**TOWN OF WINTER PARK
PLANNING COMMISSION
Tuesday, December 8, 2020 8:00AM
Online Meeting (instructions below)**

MEMO

TO Planning Commission
FROM Hugh Bell, Planner
THRU James Shockey, Community Development Director
DATE December 8, 2020
RE Sketch Plan – Mark Kent & Kimberly Taylor Kent Trust – WANDER

RE: Wander-Winter Park Townhouses Sketch Plan Review 1
JVA Job #1566.118c

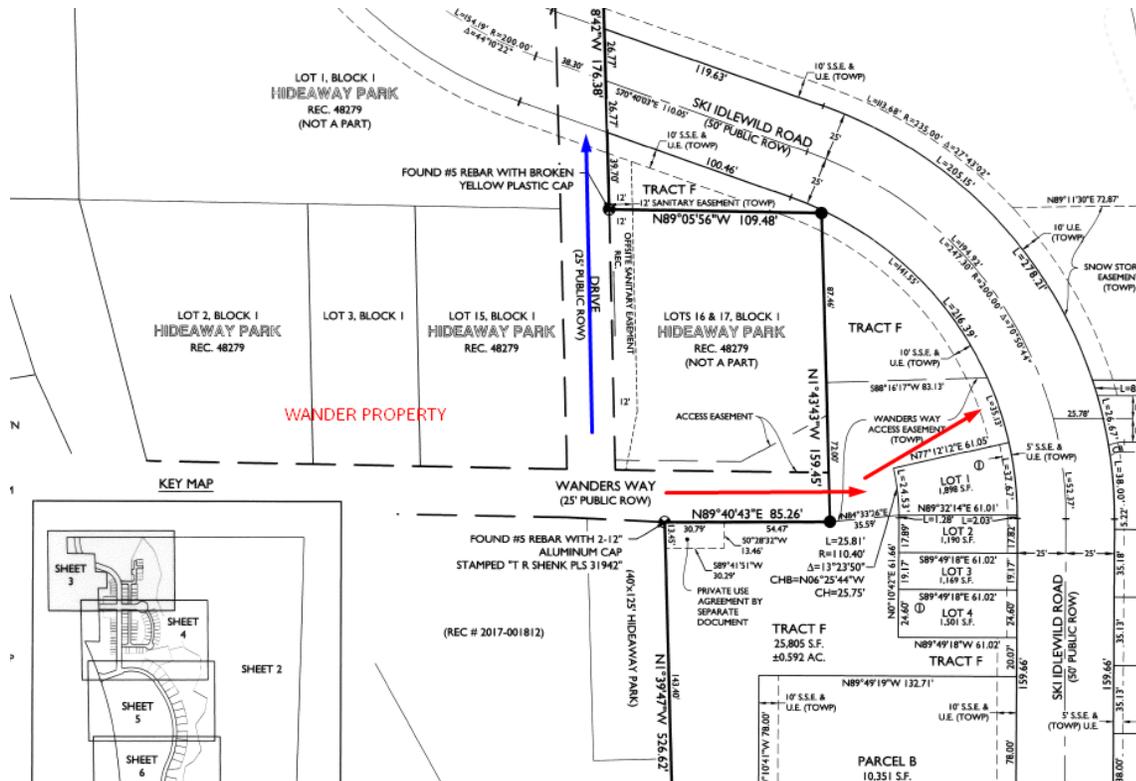
Vehicular access to the property is proposed via a 25' north-south public right-of-way that connects at the northern terminus to Ski Idlewild Road (shown below in blue). The full extent of vehicular access to existing Town roads is not depicted on site plans as required in Section 2.2 (Sketch Plan) in the Standards and Specifications for Design and Construction ("Standards").

Roam at Winter Park Filing 1 dedicated a public access easement to the east of this property (shown below in red) to allow access to Ski Idlewild Road. Staff recommends the applicant access Ski Idlewild Road via this access easement and not the 25' north-south public right-of-way. Staff supports the applicant's proposal to eliminate the Wanderer's Way vehicular access point to Highway 40 as this is an unsafe intersection with poor visibility. The Downtown Plan (2020) supports this recommendation and advocates limiting and consolidating vehicle access points in downtown and connecting parcels with more internal connections (Section 3.1.3, Access Management).

The road within Wander (currently unnamed) is expected to generate 88 ADT thus classifying it as a “low volume road”. Staff is unsure if the Traffic Impact Analysis includes the north-south 25’-wide R.O.W. in this ADT calculation. Staff recommends the Commission request that the applicant clarify the extent of the low volume road ADT calculation.

Snow Storage Plan
Scale: 1/32" = 1'

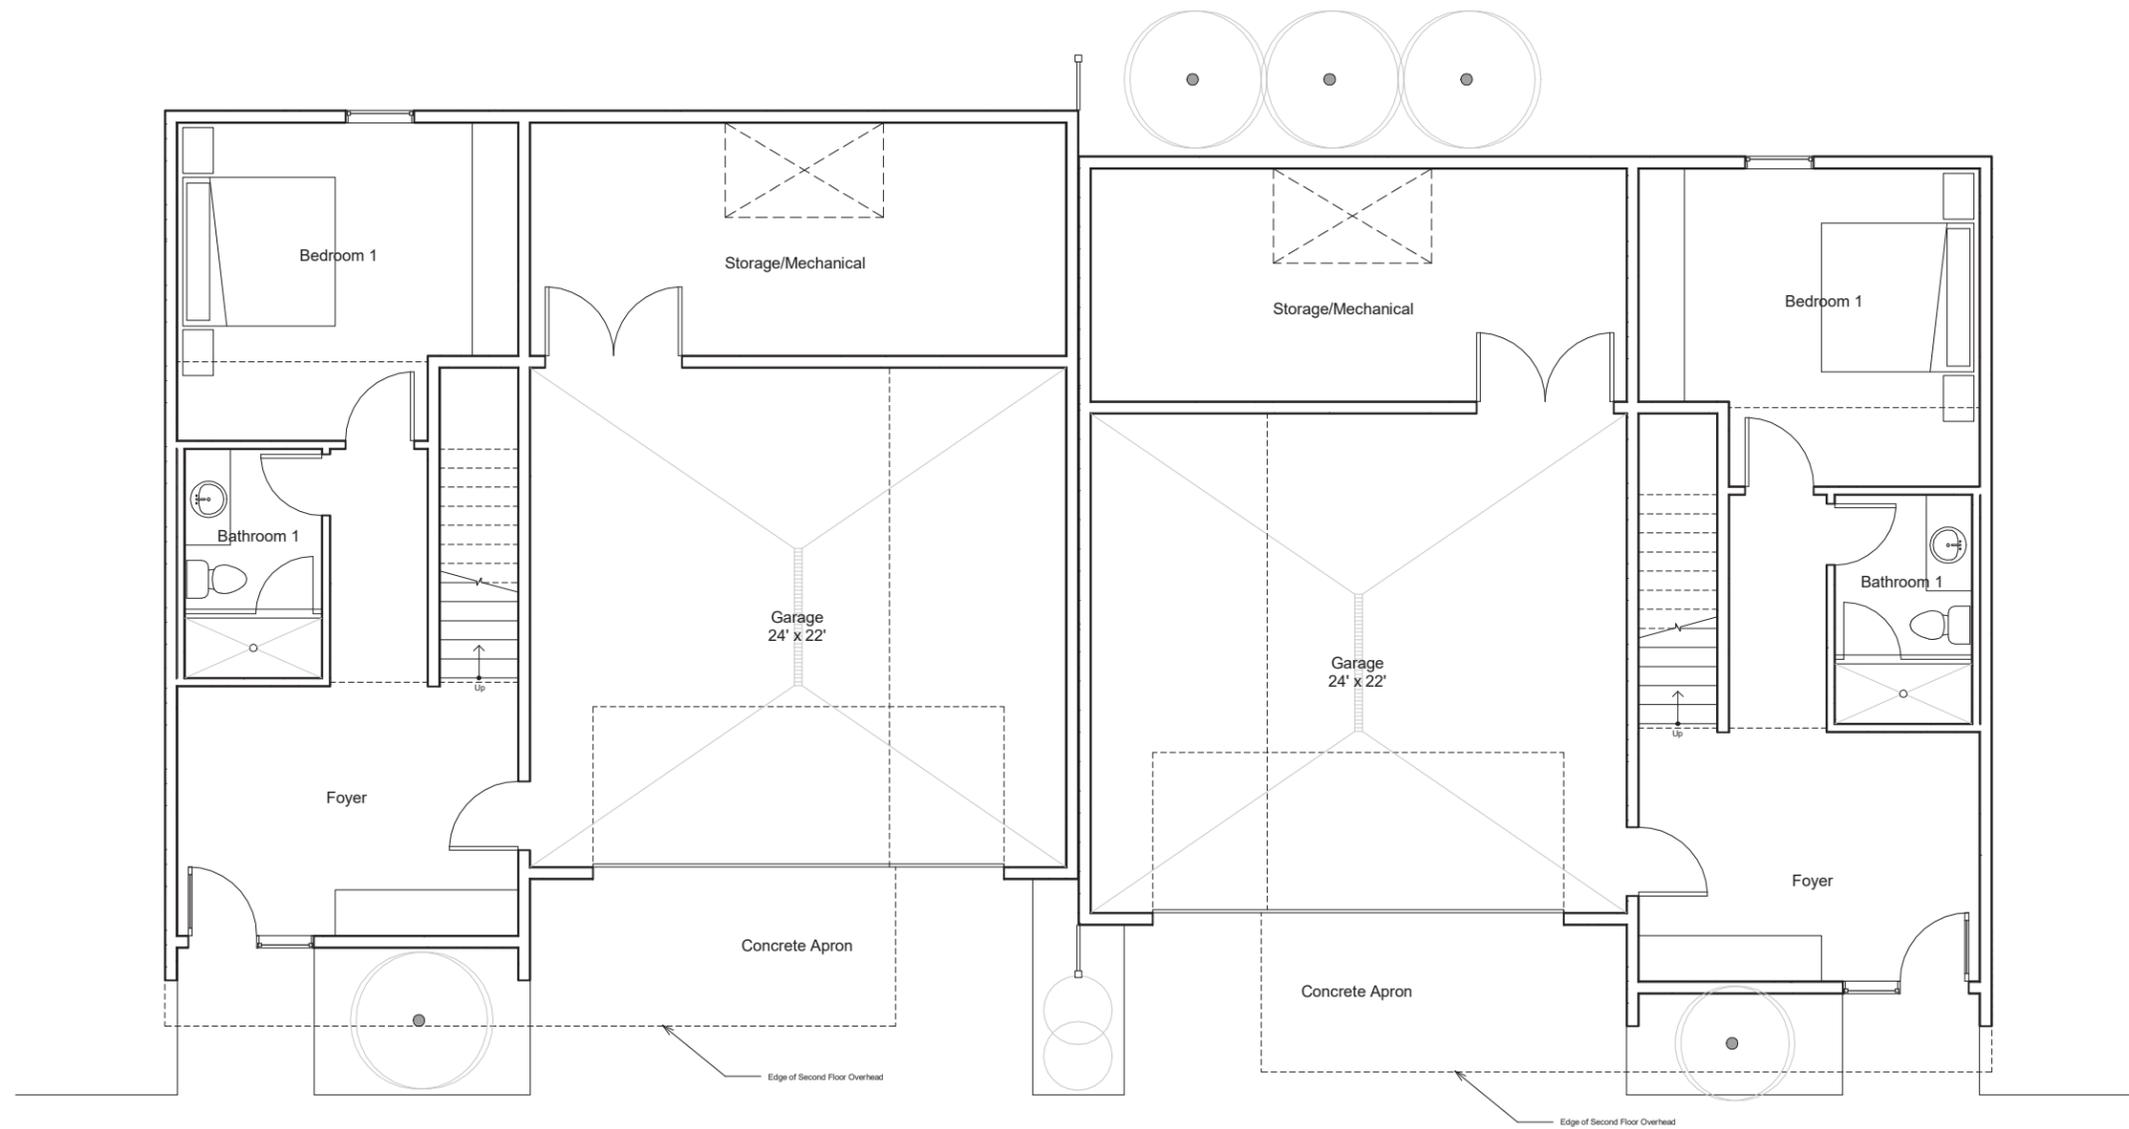
The applicant has shown proposed snow storage locations on the sketch plan, totaling 3,760 sq. ft. They are proposing snow storage areas for 30.7% of the driving surfaces, parking areas, and pedestrian walkways (25% is required per Section 3.11 (Snow Operations) in the Standards). Overall, the applicant has shown snow storage in logical locations throughout the development, but there are several problematic areas. Most areas are within 4’ from the roadway edge, which is prohibited per the Standards. The site plans do not clearly depict lot lines or what land will be maintained by a homeowner’s association; per the Standards, private land not maintained by a homeowner’s

association shall not be used for snow storage. Snow storage shall not be within 3' of utilities; staff is unable to confirm conformance because utilities aren't depicted on a site plan (this is not a sketch plan requirement). Additionally, it appears the Intersection Sight Triangle is compromised at the intersection of the low-volume road within Wander (currently unnamed) and the north-south 25'-wide R.O.W. lying perpendicular and immediately east of that low-volume road.

Staff recommends the Commission request that the applicant clarify the extent of the low volume road ADT calculation and thereafter ensure the Intersection Sight Triangle is not compromised by snow storage areas. Applicant shall refer to Figure 8 in the Standards to determine the appropriate Intersection Sight Triangle area.
